**INTER - OFFICE COMMUNICATION**

**SUBJECT:** Administrative Approval for Petition No. 2006-22 by Live Oak Development Partnership, LLC.

BY: DEBRA D. CAMPBELL  
Live Oaks Property  
Rezoning

SHEET NUMBER  
RZ-1

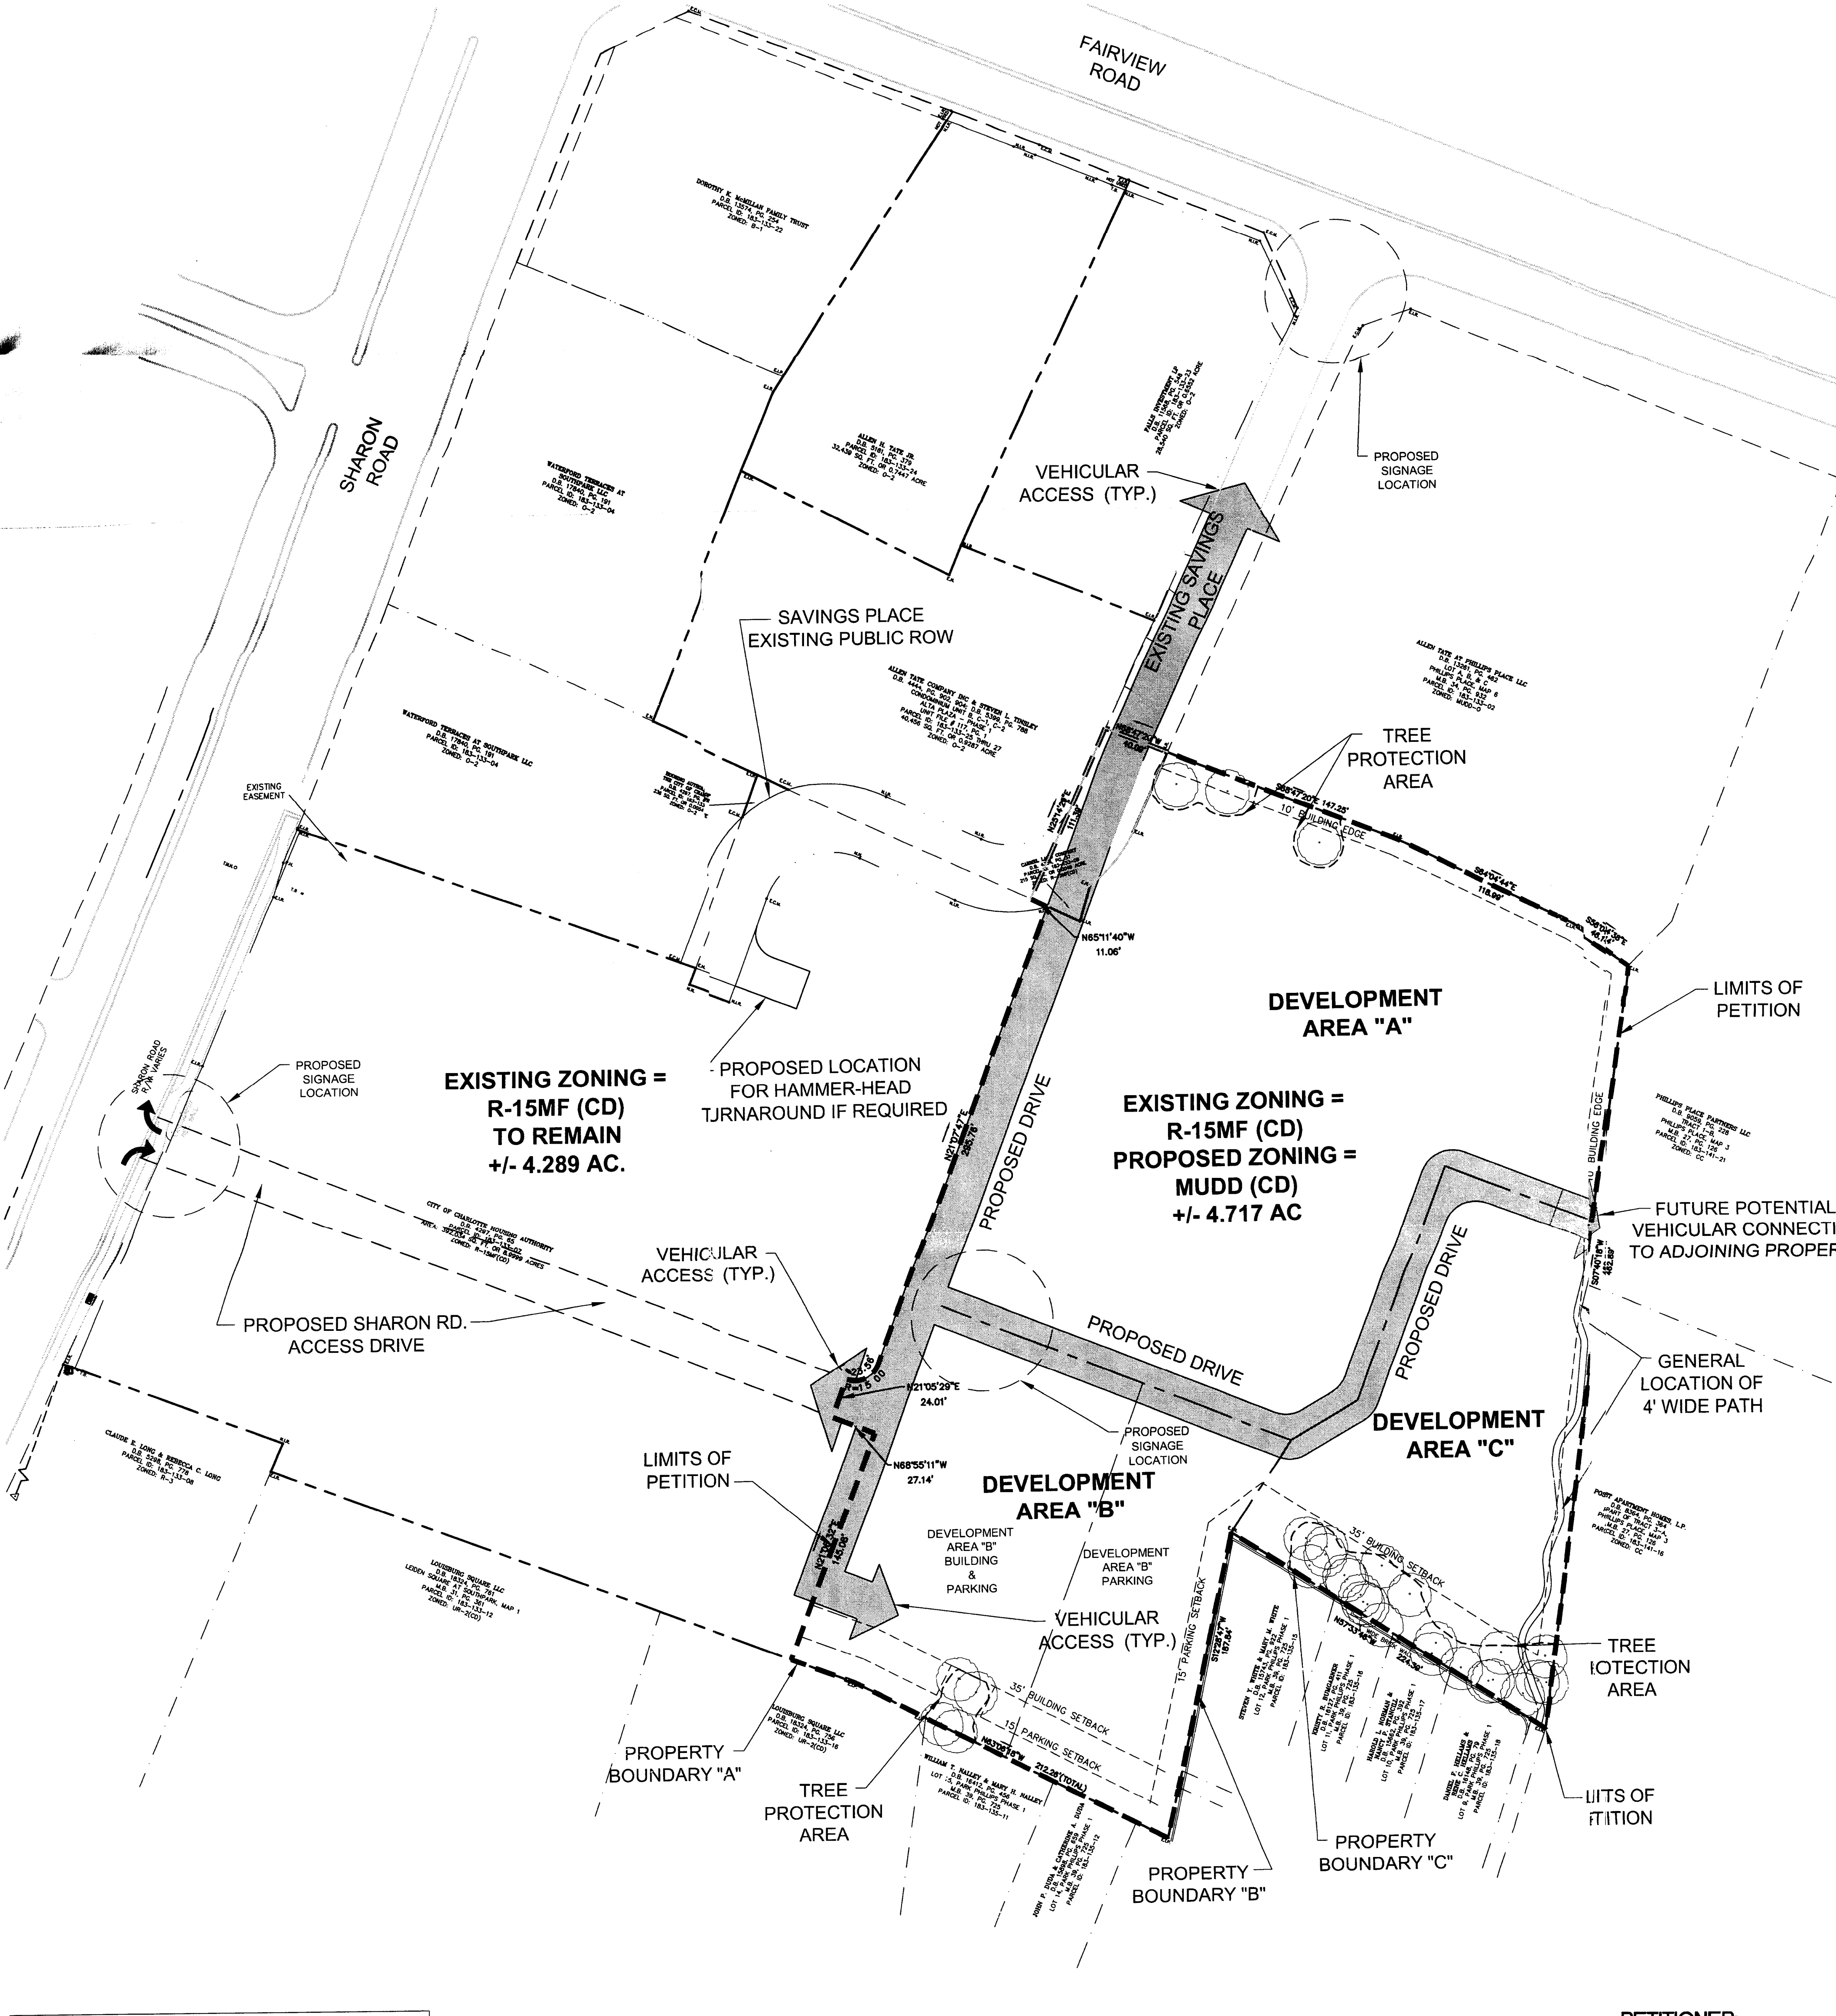
Attached are revised plans for the above petition. The plans have been revised to allow balconies, within buildings constructed within area "B", on the first and second level facing south toward boundary "A". Since this change is minor, I am administratively approving these revised plans. Please use these plans when evaluating requests for building permits and certificates of occupancy.

- i. Structured Parking within Development Area B adjacent to property boundaries A, B, and C will not exceed 14 feet in height as measured from the average elevation along the perimeter of the structure to the elevation of the parking surface of the Parking Structure. Opaque walls or other architectural treatments for screening parking from adjacent properties may occur within the Development. Balconies within development Area "C" will only be allowed to face east and west, within the Site, and will not be allowed to directly face property boundaries "A" and "C". Balconies within Development Area "B" may occur on all building sides, however those balconies facing property boundary "A" may only occur on the first and second levels.
